ADDENDUM NO. 1

Job No. F70C616E
SAND ISLAND STATE RECREATION AREA
SEWER SYSTEM IMPROVEMENTS
PHASE 2: PUMP STATION 3 RELOCATION & FM 3 REPLACEMENT
Honolulu, Oahu, Hawaii

02/22/21

| 1 | ADDENDUM NO. 1: NEW SHEET | 7 of 25 | 2/19/2021 | | |
|--|---------------------------|-------------|-----------|------|----------|
| APPROVED: | | DRAWING NO. | C006B | | |

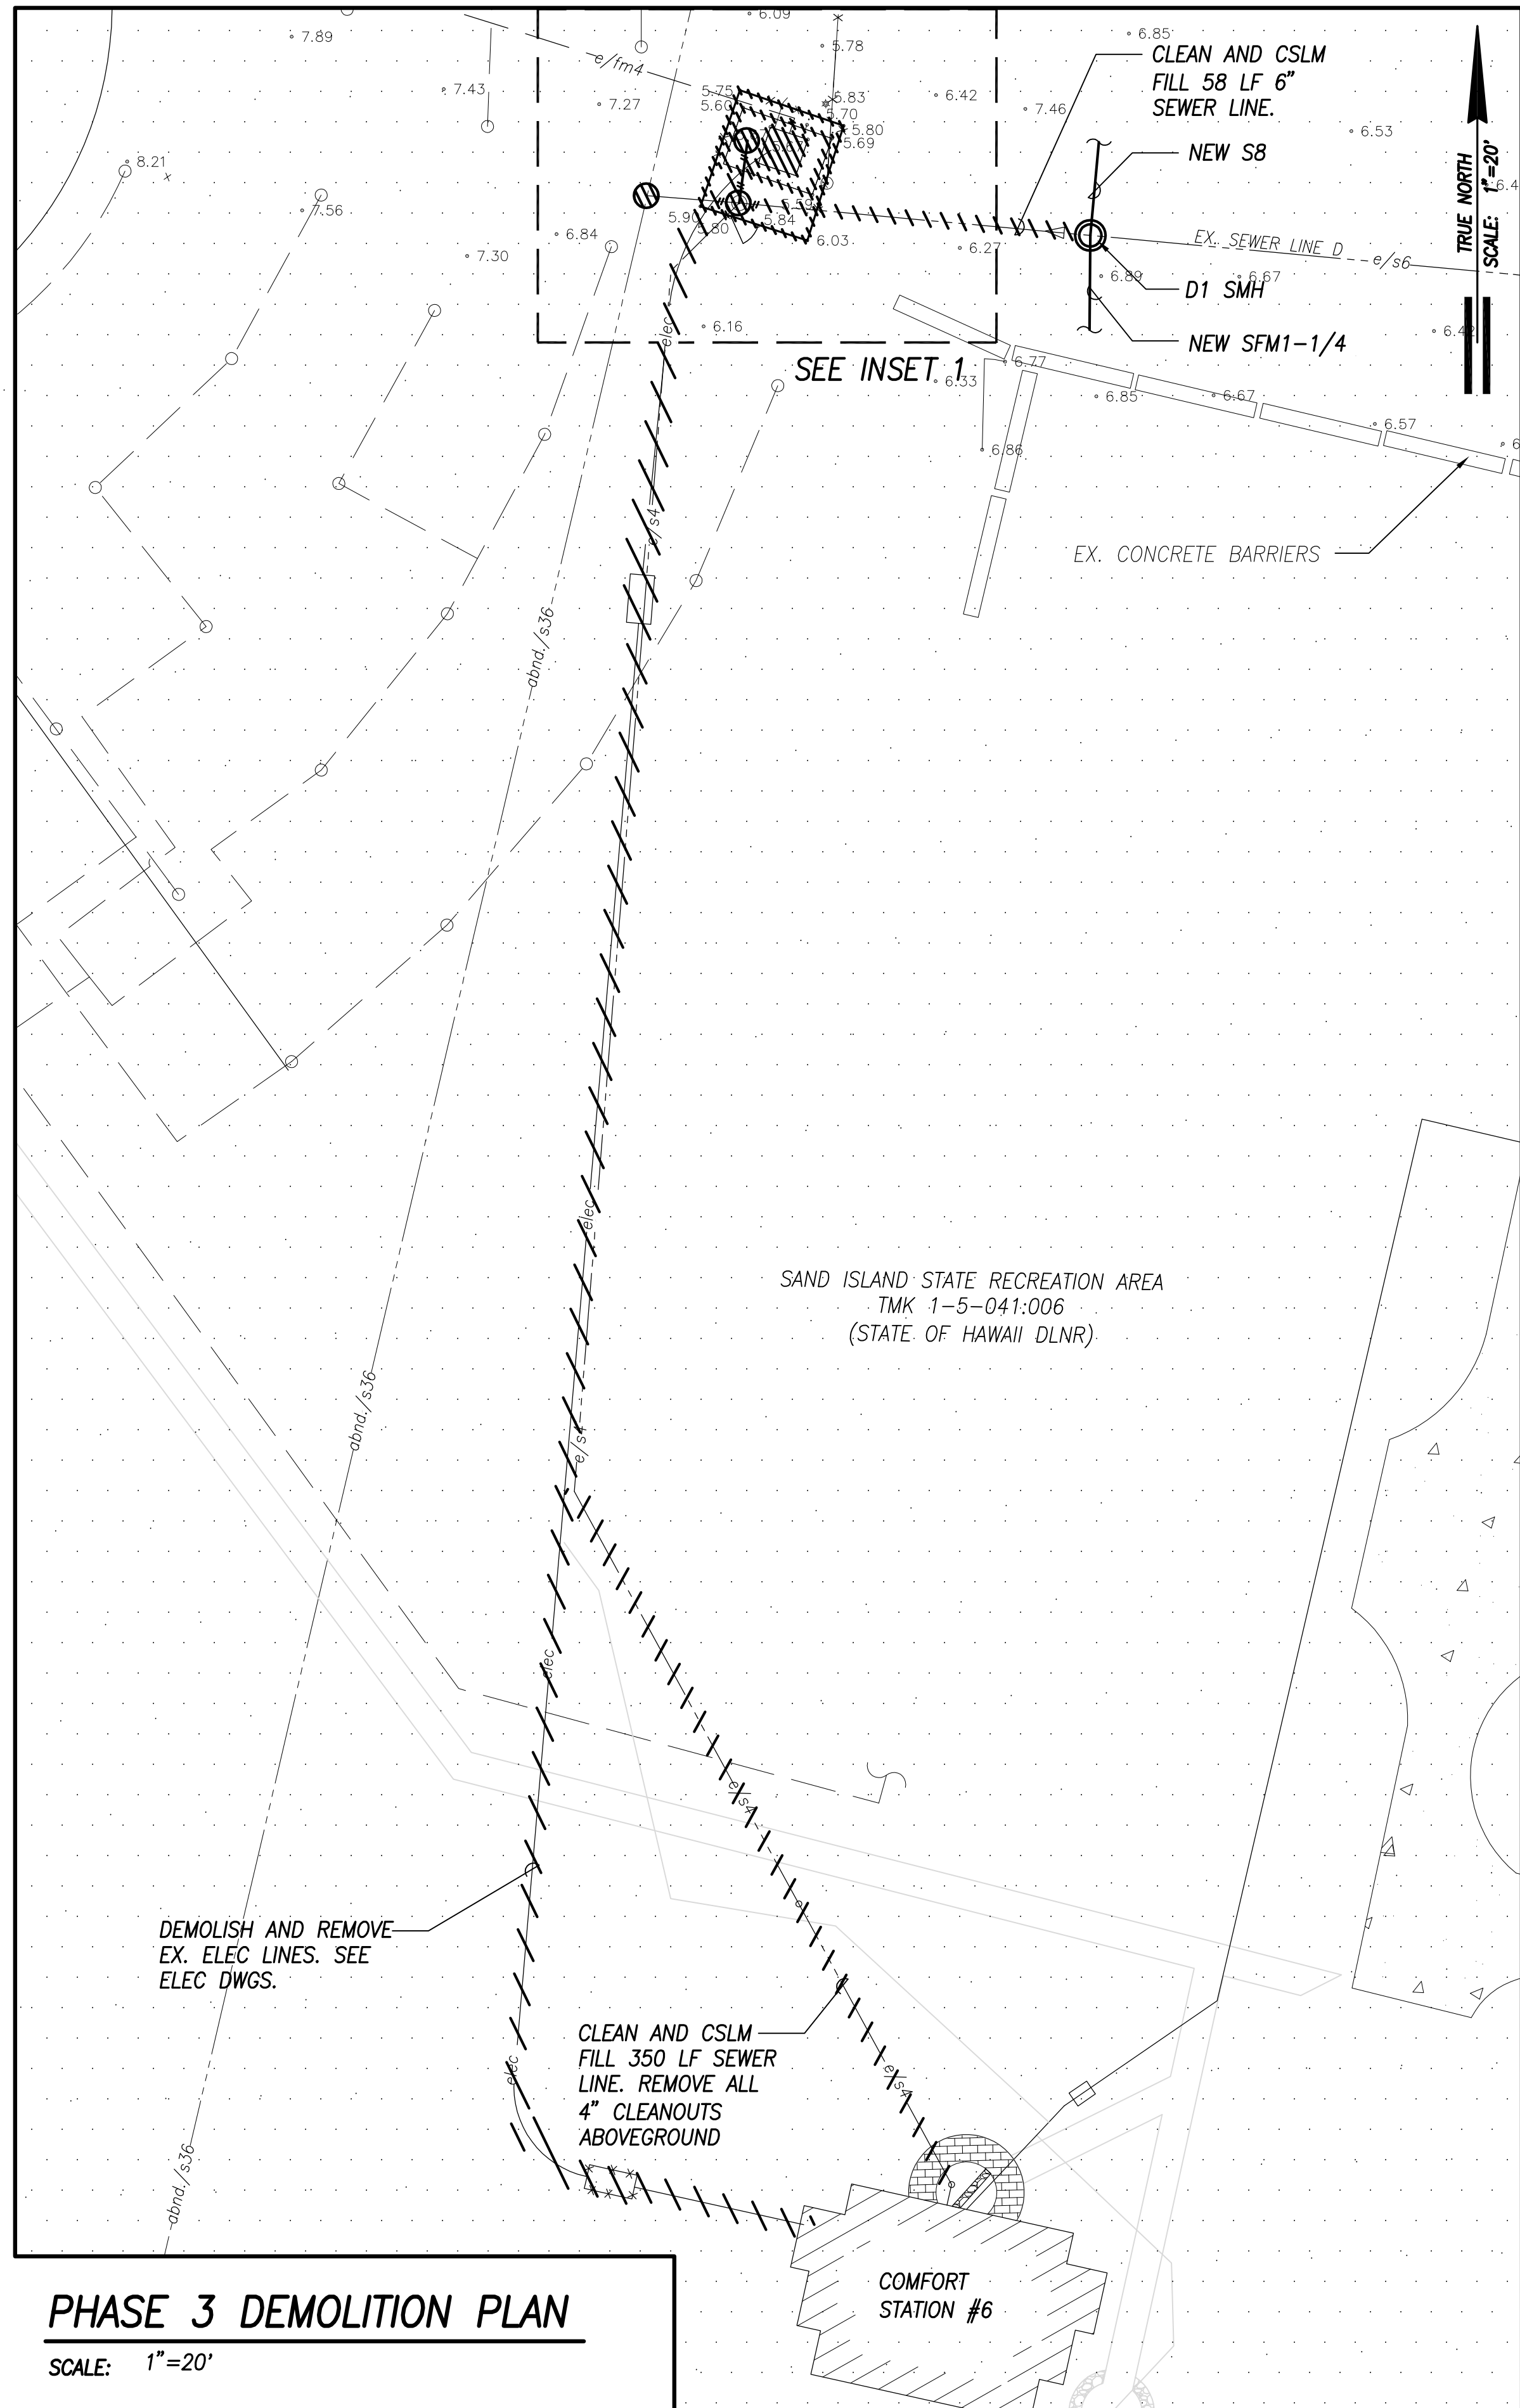
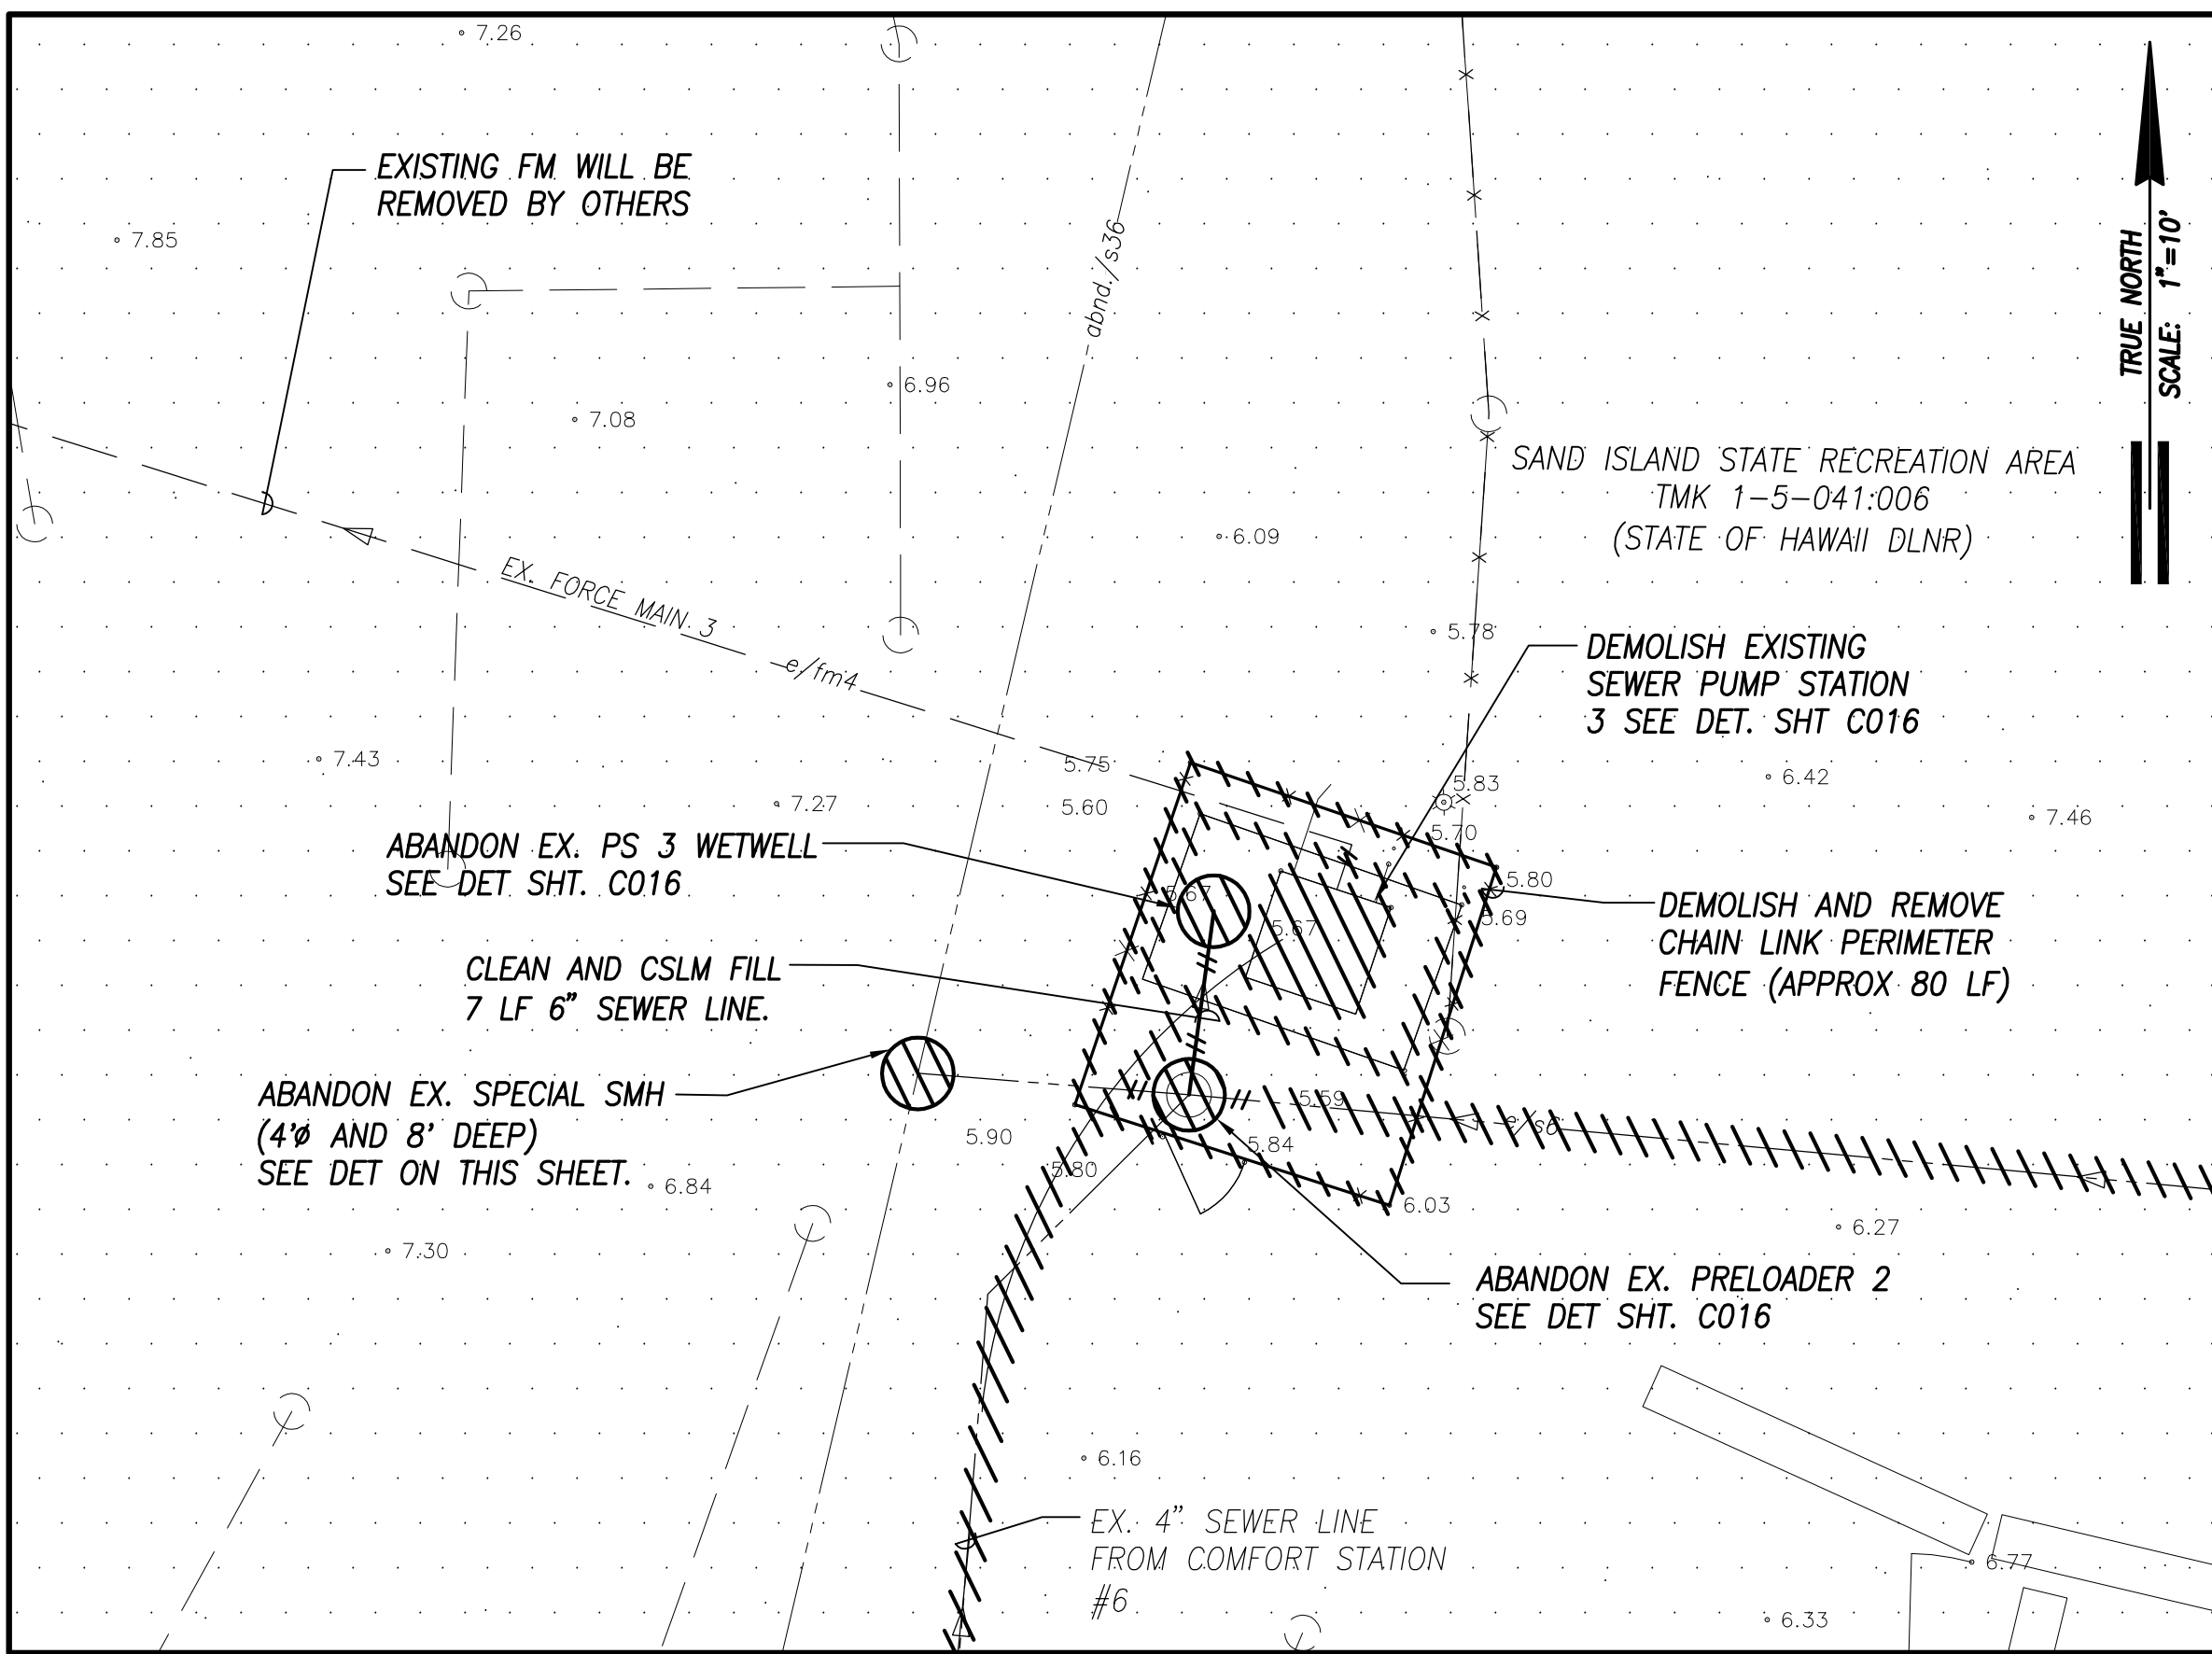
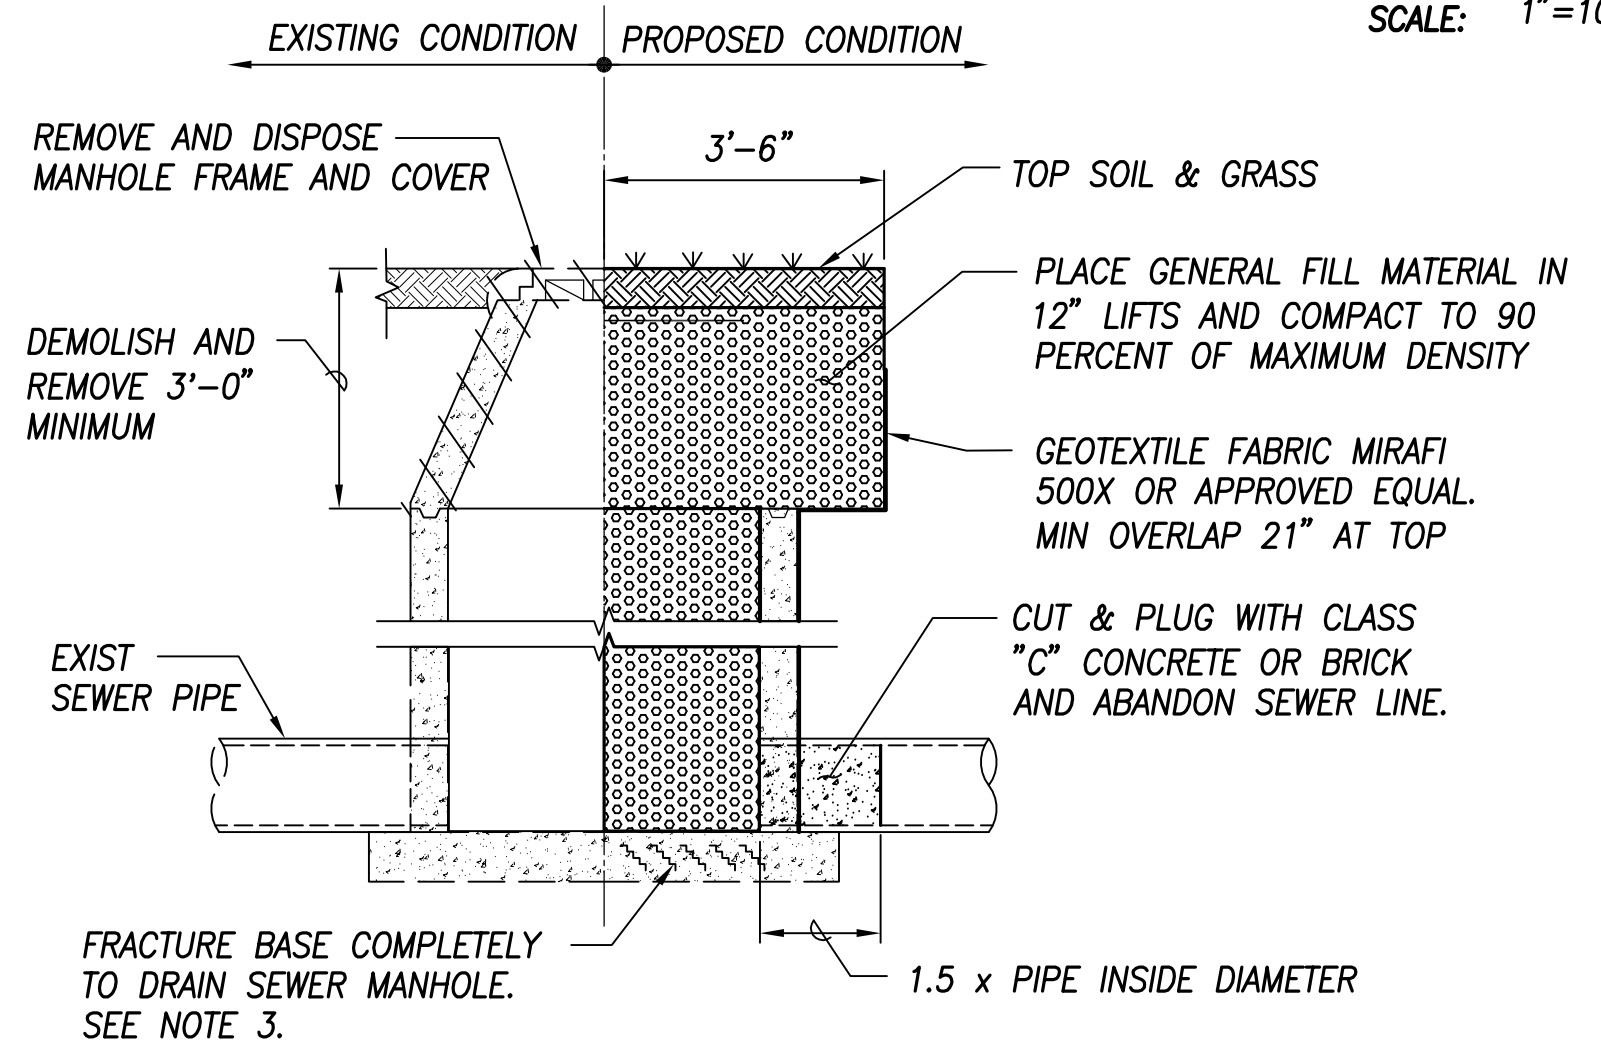
36. Bid Item #4 – Abandon Existing Special Sewer Manhole, CLSM backfilled. Plan Sheet 7, Detail “Inset 1” state “See Detail Sheet C016” regarding this bid item. However, a detail has not been provided in the plans. Please provide a detail for the abandonment of this manhole.

Answer: See new drawing C006B for detail in this addendum.
